NIAGARA OFFICIAL PLAN

Appendix 9 - PDS 41-2021

Urban Settlement Area Assessment Review and Comments

Settlement Area Boundary Review – Assessment Responses

SABR ID: 1007

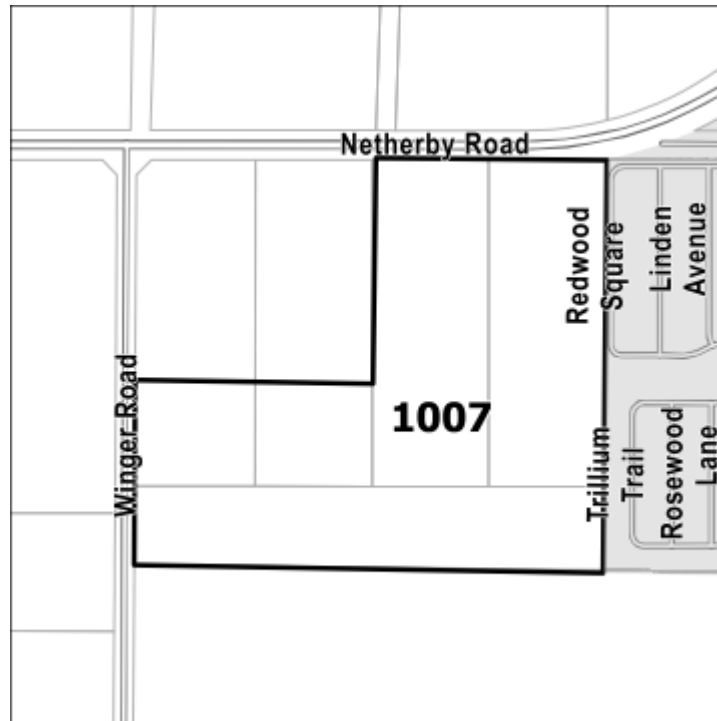
Comment: Low/Less Feasibility - some limited availability for growth capacity, not realistic to expand upon treatment system capacity, would need to connect to Anger Ave or Potentially the new SNF WWTP, wet weather issues in Fort Erie

Comment: New extensive collection system required, would require significant trunk infrastructure, no gravity outlet available

Comment: Appears to have env and agri features present

Comment: not that feasible to support additional growth unless an overall extensive servicing strategy and alternate treatment plant and associated supporting infrastructure system is provided

Comment: Rosehill WTP has capacity

Comment: Has a Regional trunk watermain adjacent to it but would require a local distribution system - Additional storage in FE being studied

Comment: Located along/nearby the identified route for the future NGTA corridor. Convenient access to the QEW via RR 25 Netherby Road, which is planned for future operational improvements per the 2017 TMP. Good access to Regional roads including RR 25 Netherby Road which borders the subject lands, as well as the nearby RR 116 Stevensville Road/Sodom Road.

Comment: Until the alignment for the NGTA corridor is known, a local road network cannot be easily established without risking major impact in the future.

Comment: Per the 2017 TMP, future improvements are planned on RR 25 Netherby Road west of the QEW, and on RR 116 Sodom Road north of RR 25 Netherby Road. Further improvements may be required to improve access to the future NGTA corridor. Intersection improvements would appear to be needed at Winger Road and RR 25 Netherby Road.

Comment: Basic cycling facilities exist on RR 116 Stevensville Road. Planned future improvements on RR 25 Netherby Road present an opportunity to add/enhance active transportation facilities. The future NGTA corridor could present a barrier for active transportation, and connections will require planning once its alignment is known.

Comment: Watercourse bisects parcel and crossings may be required

Comment: Site 1007 is in the watershed planning area FE-1 and is assessed as modest impact.

Comment: Outlet to watercourse and watercourse corridor can be improved

Comment: Gentle slope towards watercourse

Comment: There are nearby livestock operations. Further MDS review may be required

Comment: Site 1007 is not in or within 500m of a known deposit of mineral aggregate resource. Site 1007 is not within 1000m of an existing mineral aggregate operation.

Comment: These lands are being assessed as community lands in light of the adjacent residential use which would effectively preclude employment. The ability to offer complete community contribution is fairly limited and assessed as having a lower contribution in that regard.

Comment: The ability to meet community land need for the municipality by inclusion of these lands is generally lower given the size of the site. If there were certainty related to the broader candidate lands being included, there collectively there would be a more favourable impact. On their own, they remain lower.

SABR ID: 1064

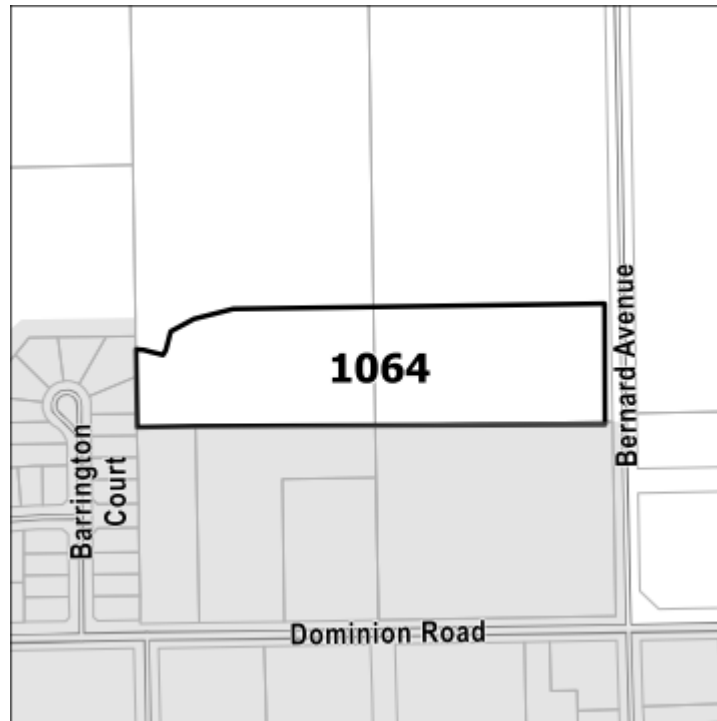
Comment: Some growth capacity available at Crystal Beach WWTP but additional growth beyond these lands may require capacity expansion

Comment: Within the Shirley Rd SPS - plans for capacity expansion, need to review servicing plan to ensure elevations and downstream capacity available, new sewer collection system required, wet weather issues in Fort Erie

Comment: could support some additional lands but depends on servicing plan and capacity review of collection system

Comment: Has a Regional trunk watermain adjacent to it but would require a local distribution system - Additional storage in FE being studied

Comment: Relatively close access to Provincial Highway 3. Access to QEW is further but several Regional roads provide connections. Easily accessible by RR 1 Dominion Road.

Comment: Small site which limits opportunity to develop full hierarchical road network.

Comment: Located in close proximity to the Friendship Trail, with connections possible. Existing cycling facilities on RR 1 Dominion Road, which provide connection to urban areas and recreational destinations to the west and west. Some infill cycling facilities planned to the east as per 2017 NR TMP which will improve connections to the north and south.

Comment: Partially in PNHS

Comment: Mapped and unmapped features may impact access

Comment: Site 1064 is in the watershed planning area FE-2 and is assessed as a modest impact

Comment: No species identified - veg cover may support species

Comment: Limited grade changes that flow toward watercourse

Comment: This site appears to have a livestock operation to the north. Further MDS review may be required

Comment: Site 1064 is on the edge of an area of known deposits of mineral aggregate resource. Site 1064 is not within 1000m of an existing mineral aggregate operation. Although the site is on a known deposit of mineral aggregate resource the rural development patterns to the north mean that a new mineral aggregate operation is highly unlikely and the impacts are negligible.

Comment: The lands are characterized more in keeping with a rounding out existing settlement area and are smaller in size and limited to the natural features along its northerly limits. That lands identified within provincial Natural

Comment: Addition of these lands is assessed as favourable for contribution to land need and from the perspective of limited locations in the easterly portion of this particular settlement area might see expansion potential. Single or few owners assists in process potential.

Comment: The addition of these lands is assessed as having minimal impact on neighbouring or nearby lands. Appropriate provision for natural features appears to be feasible.

SABR ID: 1116

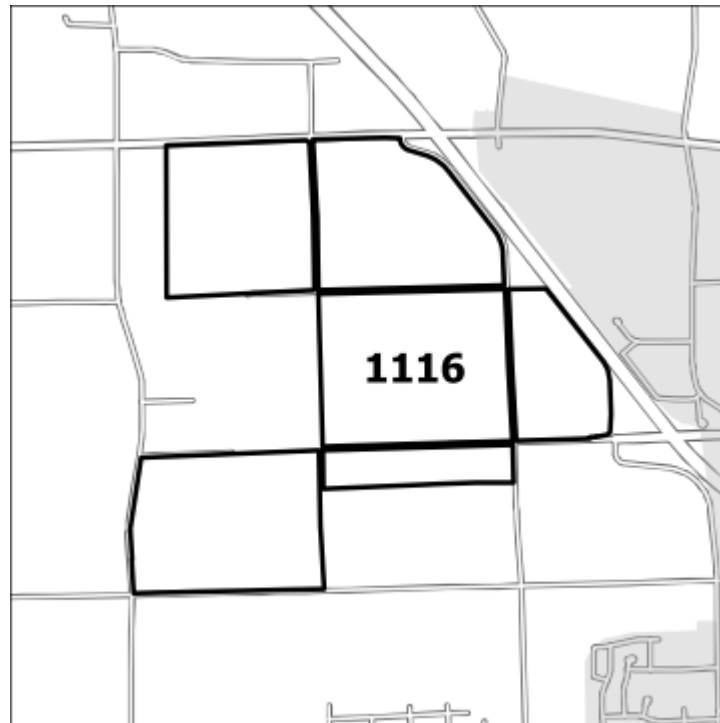
Comment: Low/Less Feasibility - no direct outlet to an existing WWTP - would need to go to Anger Ave WWTP - some availability for growth capacity

Comment: Less Feasible - SPS required with QEW crossing, need to review downstream system and potential upgrades, would require significant trunk infrastructure depending on servicing plan, no gravity outlet available, wet weather issues in FE

Comment: not that feasible to support additional growth unless an overall extensive servicing strategy and alternate treatment plant and associated supporting infrastructure system is provided

Comment: Less Feasible - QEW crossing for new watermain, required looping, needs extension of watermains and distribution network - Review of fire flow and capacity required - Additional storage in FE being studied, need to review fire flows

Comment: Proximity of this collection of parcels next to the QEW between two full access interchanges affords it the highest level of access. Good Regional road connections with RR 19 Gilmore Road and RR 21 Bowen Road in close proximity.

Comment: RR 21 Bowen Road was recently reconstructed and would serve the northern parcels well. However reconstruction of Gilmore Road west of the QEW would appear necessary to serve the southern parcels, and the road could be a candidate for upgrading to the Region (currently it is a Regional Road only east of the QEW). Depending on the size of the development and the amount of site traffic to be generated, collector roads in area may require some improvements.

Comment: New cycling facilities were added on RR 21 Bowen Road when recently reconstructed. The 2020 FE ATMP has highlighted that a future Paved Shoulder is planned on Sunset Drive, east of the requested lands, and a future Signed Bike Route on Ridgemount Road from west. Future connections are possible.

Comment: PNHS runs through middle of area - corridor function to be considered

Comment: Access is limited due to scope and location of ENV features - corridor function needs to be considered

Comment: Site 1116 is in the watershed planning area FE-3 and is assessed as a high impact.

Comment: None mapped but habitat may exist

Comment: More significant grade changes in NW quadrant

Comment: This is an agricultural area with class 2,3,4 soils

Comment: This site appears to have many surrounding livestock operations. Further MDS review may be required

Comment: This site is part of the previously approved Canadian Motor Speedway. Lands are currently leased for agricultural field crop. Conversion of this site would have a modest impact on the broader agrifood system.

Comment: Site 1116 is a number of parcels. Site 1116 is within an area of known deposit of mineral aggregate resource. Site 1116 is adjacent and within

Comment: These lands have been identified for employment interest. The entirety of the lands identified are large in area and do not necessarily share the same criteria assessment potential and description in these comments will be used.

Comment: Addition of these lands from east to west in sequential manner would act in addressing identified land need for employment purpose. Consideration should be given to lands north of Bowen in conjunction with overall land need and may reduce what would be required from this large land assembly in order to meet forecasts. For the purposes of assessment, this site (or easterly portions thereof) represent higher favourability for inclusion to address employment need. It can be noted that active / licensed aggregate operations are present to the west of these lands and appropriate separation is

Comment: From a perspective of employment use, impacts on neighbouring or nearby lands are considered minimal impact as the site is situated considerable distance from the more densely populated community area providing higher compatibility and less land use conflict.

SABR ID: 1127

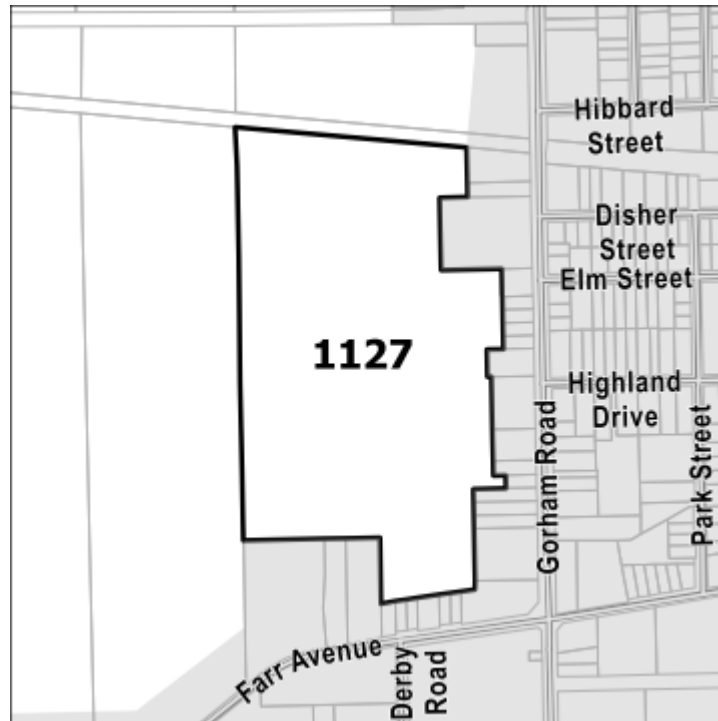
Comment: Some growth capacity available at Crystal Beach WWTP but additional growth beyond these lands may require capacity expansion

Comment: Need to review servicing plan to ensure elevations and downstream capacity available, new sewer collection system required, wet weather issues in Fort Erie

Comment: could support some additional lands but depends on servicing plan and capacity review of collection system

Comment: Has a Regional trunk watermain adjacent to it but would require a local distribution system - Additional storage in FE being studied

Comment: Relatively close access to Provincial Highway 3. Access to QEW is some distance away, with several potential routes accessing it. Site is accessible from Gotham Road, which becomes Regional (RR 19) to the north of the subject lands.

Comment: Development in this parcel could directly connect to the Friendship Trail. Existing cycling facilities on Gorham Road adjacent to the site, with infill facilities planned to extend southerly (2017 NR TMP). Once constructed, this will connect site to recreational and waterfront destinations to the south.

Comment: Woodlands, Wetland Buffer, Fish Hab and Corridor functions - western half heavily impacted by PNHS

Comment: Access may be impacted by NHS on south end but options available on east end

Comment: Site 1127 is in the watershed planning area FE-8 and is assessed as a minimal impact.

Comment: LID would be beneficial as large portions of lands are cleared of veg

Comment: No species records but habitat may exist

Comment: ~8m grade change moving east to west

Comment: some surrounding barns to consider

Comment: Site 1127 is not in or within 500m of a known deposit of mineral aggregate resource. Site 1127 is not within 1000m of an existing mineral aggregate operation.

Comment: A sizable parcel of land that could offer potential for complete community design principles to be implemented to enhance broader community area. Some environmental features are apparent and requiring additional study, and also be subject to satisfying Provincial NHS policy direction if lands were to be included.

Comment: Given the size of the site and single ownership, assessment is higher favourability. Careful design through local planning can assist in achieving land need identified for the community.

Comment: Inclusion of these lands would have minimal impact to neighbouring or adjacent lands. Impact to environmentally features would require appropriate study and mitigation, but appears achievable.

SABR ID: 1130

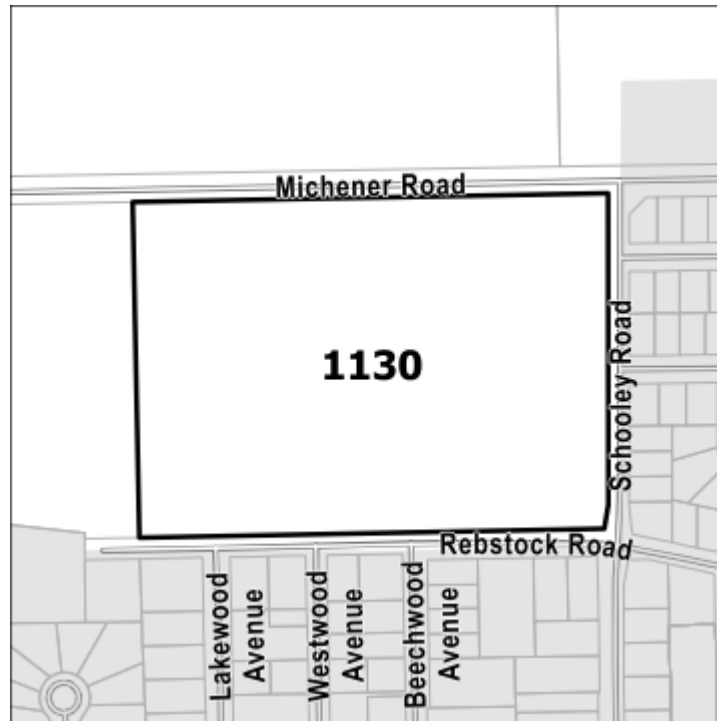
Comment: Some growth capacity available at Crystal Beach WWTP but additional growth beyond these lands may require capacity expansion

Comment: Need to review servicing plan to ensure elevations and downstream capacity available, new sewer collection system required, wet weather issues in Fort Erie

Comment: could support some additional lands but depends on servicing plan and capacity review of collection system

Comment: Local watermain adjacent to it but would require additional local distribution system - Additional storage in FE being studied - need to evaluate fire flows

Comment: feasible to support some additional lands but local distribution system capacity and fire flow assessment required

Comment: Relatively close access to Provincial Highway 3. Access to QEW is some distance away, with several potential routes accessing it. Site is accessible from Gotham Road, which becomes Regional (RR 19) to the north of the subject lands.

Comment: cursory review of the site does not present any notable constraints in terms of creating a local road network.
